ENVIRONMENTAL REVIEW COMMITTEE REPORT

Project Name: Fieldbrook Commons

Project Number: LUA12-001, ECF, PPUD

FIELDBROOK COMMONS
 PRELIMINARY PUD
 DRAINAGE CONTROL PLAN, EAST
 17040 100TH AVENUE SE
 RENTON, WA

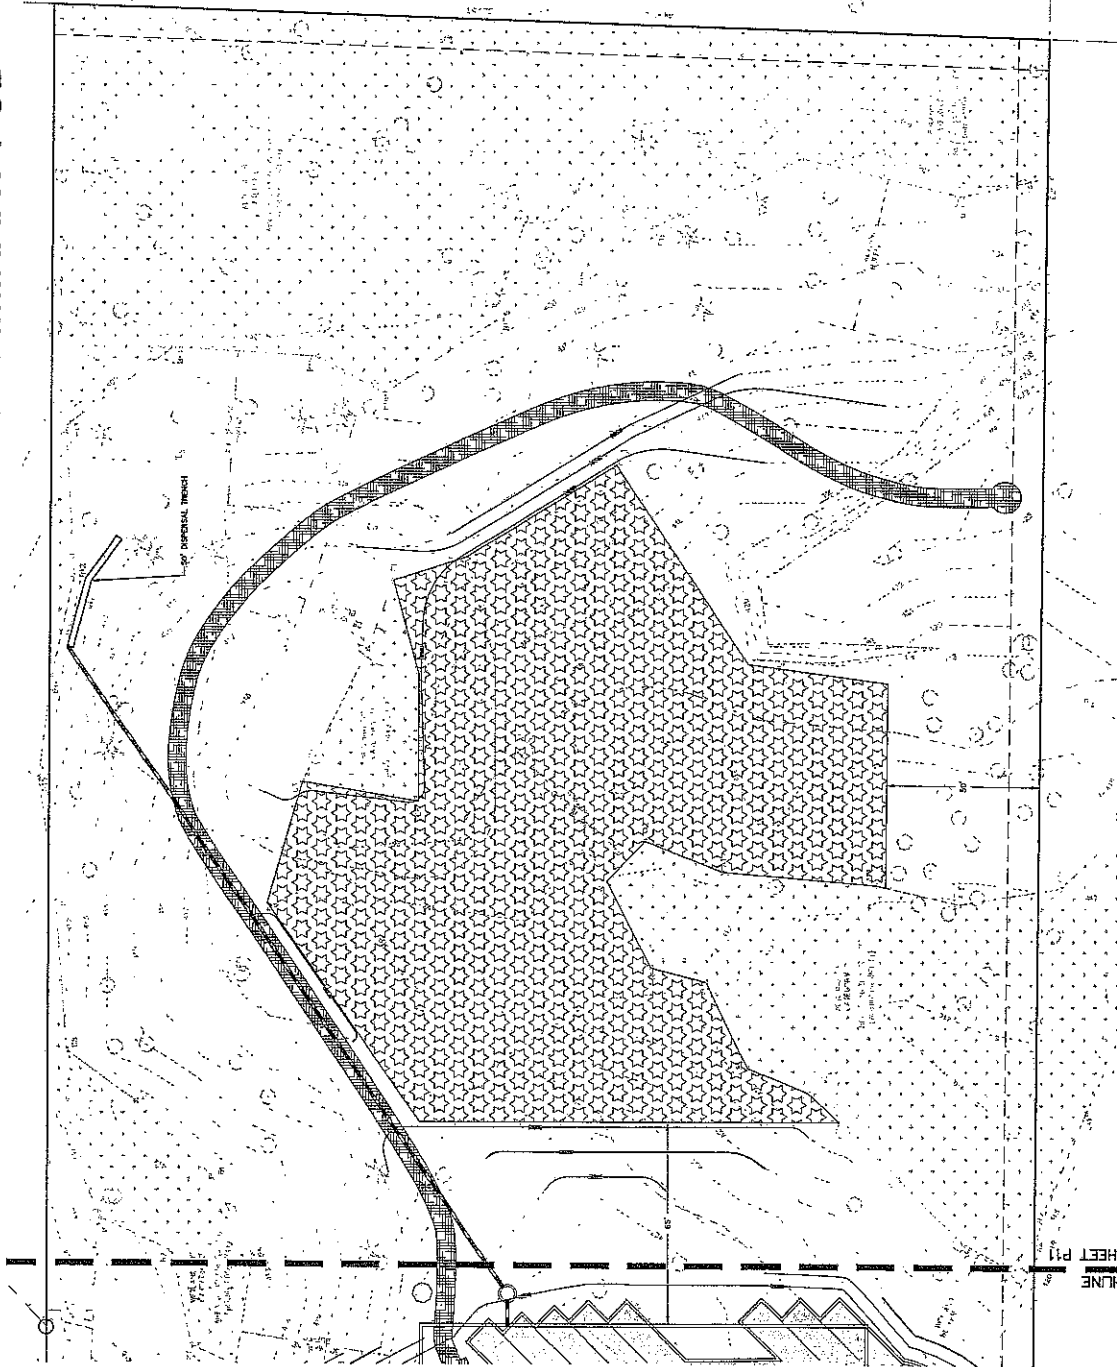
2. The conceptual utility plan submitted is showing a vault and a pond. The storm drainage needs to be consistent with any other wetlands plans in regard to location and number of vaults and ponds.
3. Plans will be reviewed in detail prior to issuance of a construction permit following land use process.
4. The project will be required to pay the Surface Water System Development Charges of \$0.405 per square foot of new impervious area. This fee is collected prior to the issuance of the construction permit.

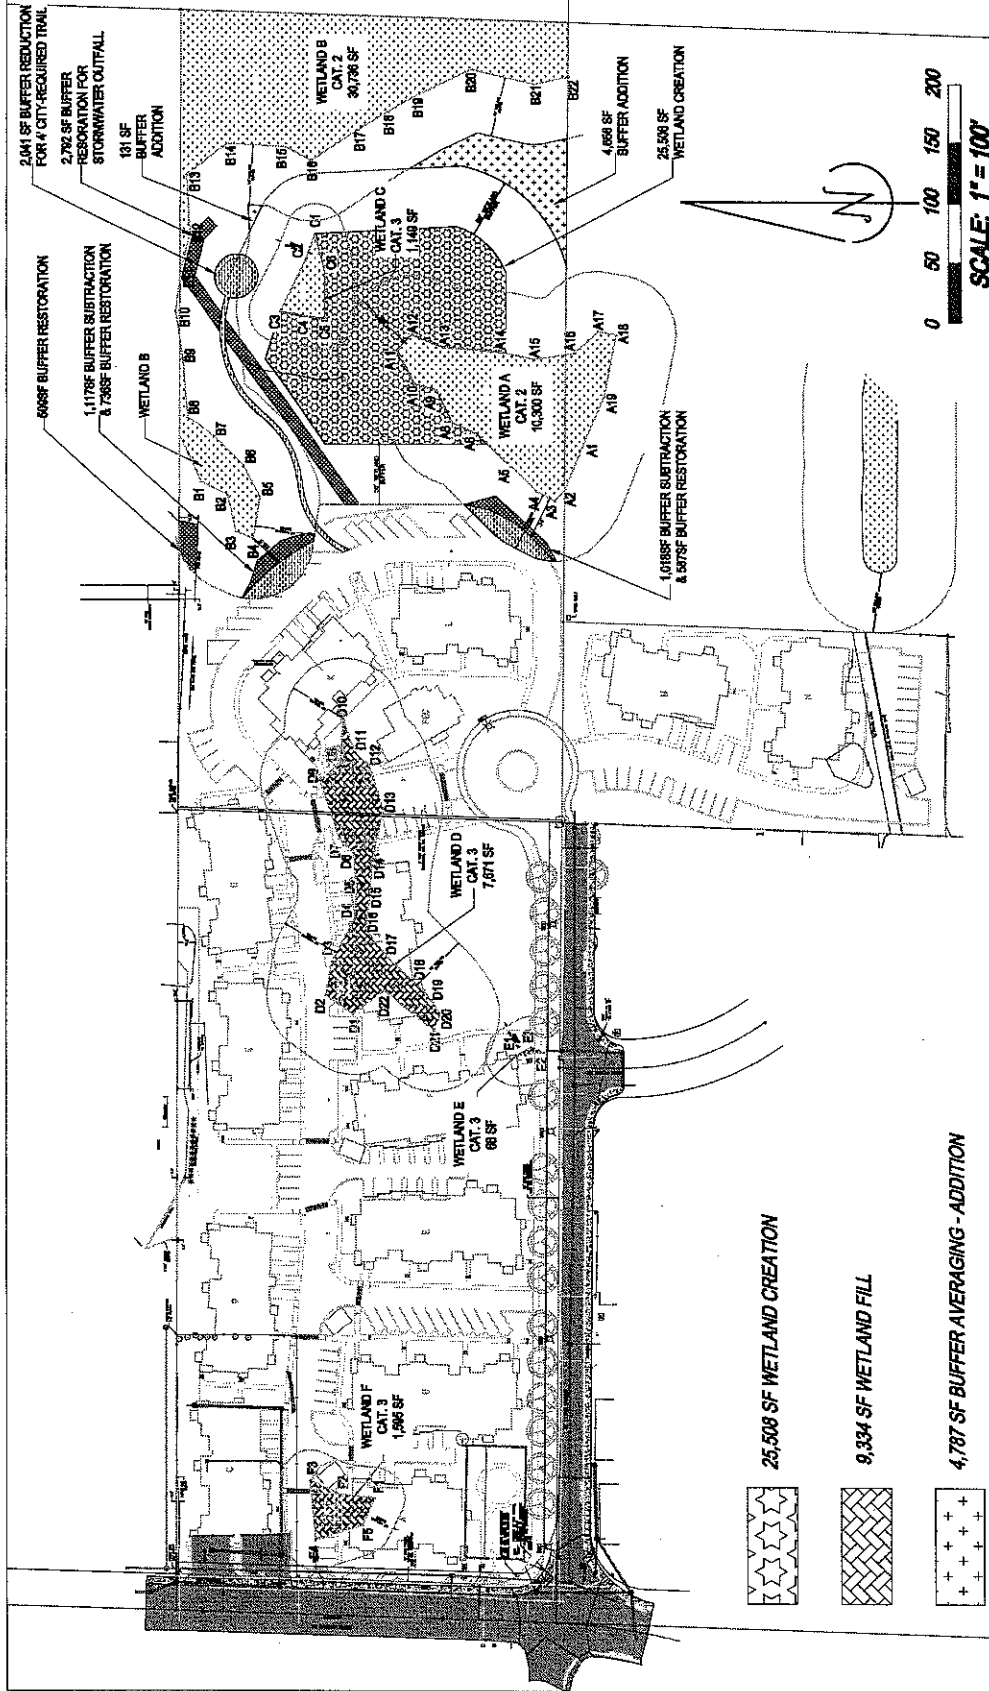
9. Please included the trial in the design addressing all portions of OTAK's report on trail impacts to the wetlands.

As required by the City, we have included a trail through the wetland buffer. This trail will be a soft surface wood chip trail that passes through the middle of the buffer area between Wetlands C and B. The
